INDESIT company

W105TXR(BG)

F027089

FIG. 1

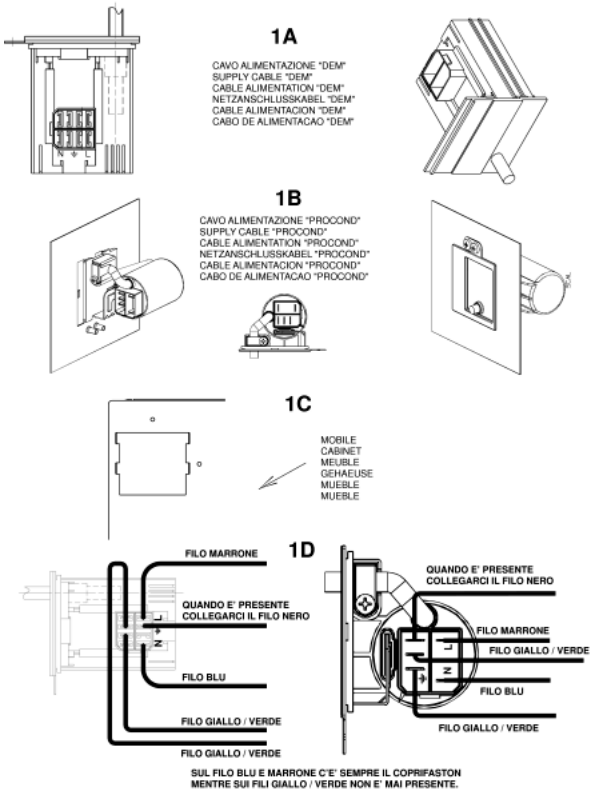
n1040276: Power supply cable + integrally moulded filter.

All appliances produced in the Comunanza (from serial no. 21008.0001), Teverola (from serial no. 21111.0001) and Brembate (from serial no. 21119.0001) factories have been equipped with power supply cables with integrally moulded filter (see fig.1 - 1A and 1B) and new units having a specific opening at the back for fixing the new cables (see fig. 1 - 1C).
The new units, together with the new cables, can be used in place of the premodification ones, by connecting the wiring to the cable, as shown in figure 1 - 1D.
The codes of the new units and of those replaced (ESI - table n1040276fig02), which will be managed until stocks run out, are given below.

The new power supply cables are:
Code 091632 - Power supply cable 3x1 schuko 1.5m+capacitance filter;
Code 091633 - Power supply cable 3x1 schuko 1.5m+inductive filter;
Code 091634 - Power supply cable UK 3x1 l= 1950mm + inductive filter;
Code 091635 - Power supply cable UK 3x1 l=1950mm+capacitance filter;
Code 091636 - Power supply cable l=2.55m AUS+inductive filter;
Code 091641 - Power supply cable l=2550mm AG +capacitance filter;
Code 091642 - Power supply cable 1.85mt SHUKO no inductive filter;
Code 091643 - Power supply cable 3x1 (CH) 1.5m+inductive filter;
Code 091645 - Power supply cable 3450mm SOUTH AF.+capacitance filter;
Code 091690 - Power supply cable shuko l2.55m KOREA+inductive filter;
Code 091689 - Power Supply cable l=2550mm AG+inductive filter.

IMPORTANT: the fixing / continuity screw is a specific self-scraping screw (code 092348) that ensures earth continuity between the filter and the unit. The same screw must be refitted in order to guarantee machine conformity.

The premodification wirings, are also managed for modified products by making the connection to the terminal block of the new cable as shown in fig. 1 - 1D.
The wiring diagrams given in the Documentation remain unchanged.

n1040285: Modified shock absorber bracket - Brembate plant

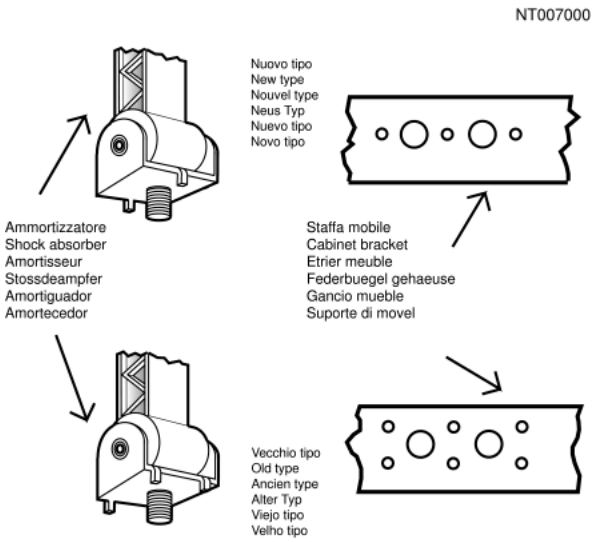
From the registration no. 30127.0001, the washing machines and Washer-Dryers produced in the Brembate factory Plant, have used modified shock absorbers with the bracket that fixes onto the cabinet.
The codes for the new shock absorbers are:
Code 093648 - Shock absorber 120N-2PIN;
Code 093649 - Shock absorber 100N-2PIN;
The modification also involved the cabinets in the fixing area that for the shock absorbers represent a different type of slotting (see enclosed figure).
To avoid the proliferation of the codes, the modified cabinets are handled with the same SAT code as the pre-modification, when replacing the cabinet you will need to check the registration number of the appliance.
In order to perform a proper task the intervention of the cabinet replacement it is recommended, that at least in the initial phase, to keep both the combination of shock absorbers in stock. The shock absorbers code 081705 (120N-4PIN) and 082327 (100N-4PIN) will continue to be normally handled.

The codes for the new cabinets are: 092794 – 091748 – 091758 – 091742 – 091756 – 091754 – 091749 – 091752 – 090931 – 090187 – 089649 – 083287.
